**1 Products affected**

**2 Type of change**

Product Change Notification					PCN_USF 1206 0.750 A		
owner	creation date	release date	released by	change order no	rev	page	D10-006-945
ganderka	2016-07-26	2016-08-09	bergerra	2010595	A	1 of 2

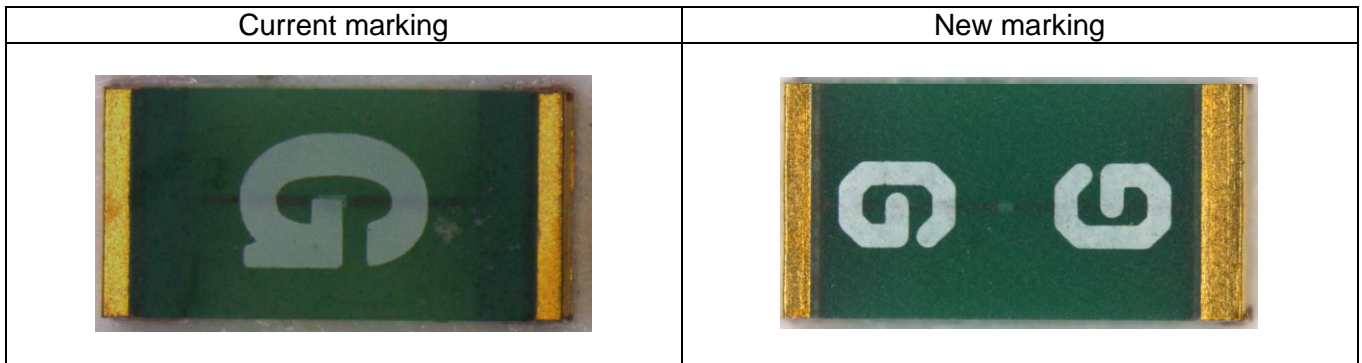
- Improved marking readability
- Change of body material

Letters do not change

- Symmetric marking to provide marking readability independent from device placement in blister.
- Necessary change of body material due to material phase out.

Form	Yes	New body material and marking adjusted
Fit	No	There are no dimensional changes.
Function	No	This is a non-functional change
Production Site	No	There is no change of the production site.
Product Label	No	No label change
Customer Action	No	Notification only
